Access Compliance Report

Public Rights-of-Way

(Curb Ramps)

Intersection ID: 3062	Main Street: LOGANVILLE_DR	Cross Street: BENFIELD_RD	Location: W
ADA ID: BDB758FC8338	Ramp Type: Perp	Initial Pass/Fail: Fail	Overall Compliance: No
Codes/Mitigation Info/Possible Solution		Field Measurements/Component Compliance	
Severity Score: 33.75

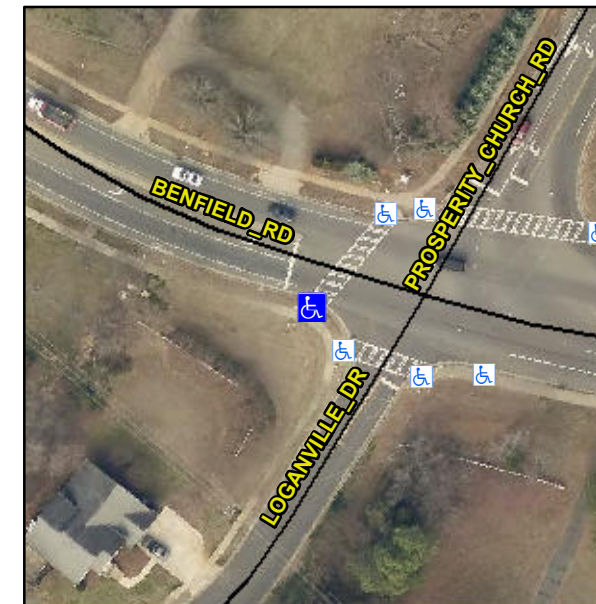
R304.5.1, R304.2.2

Compliance	Description	Data	Compliance	Description	Data
N/A	Ramp Length (in)	73.0	No	Ramp Slope (%)	20.0
No	Ramp Width (in)	36.5	Yes	Ramp XSlope (%)	1.4
N/A	Flare Type LT	N/A	N/A	Flare Type RT	N/A
N/A	Flare Slope LT (%)	N/A	N/A	Flare Slope RT (%)	N/A
N/A	Flare Traversable LT?	N/A	N/A	Flare Traversable RT?	N/A
N/A	Landing Length (in)	N/A	N/A	DWS Provided?	N/A
N/A	Landing Width (in)	N/A	N/A	DWS Contrast?	N/A
N/A	Landing Slope (%)	N/A	N/A	DWS Length (in)	N/A
N/A	Landing X Slope (%)	N/A	N/A	DWS Full Width?	N/A
N/A	Landing Curb? (Y/N)	N/A	N/A	DWS Offset (in)	N/A
N/A	Shared Landing?	N/A			
N/A	Gutter Ponding?	N/A	N/A	Gutter Slope (%)	N/A
N/A	Gutter Lip Ht (in)	N/A	N/A	Gutter X Slope (%)	N/A
N/A	Painted X Walk1?	Yes	N/A	Painted X Walk2?	N/A
	X Walk 1 Direction	To NE		X Walk 2 Direction	N/A
N/A	X Walk 1 Width (in)	108.0	N/A	X Walk 2 Width (in)	N/A
	X Walk 1 Slope (%)	0.9		X Walk 2 Slope (%)	N/A
	X Walk 1 X Slope (%)	0.9		X Walk 2 X Slope (%)	N/A

Remove & Replace Entire Ramp.
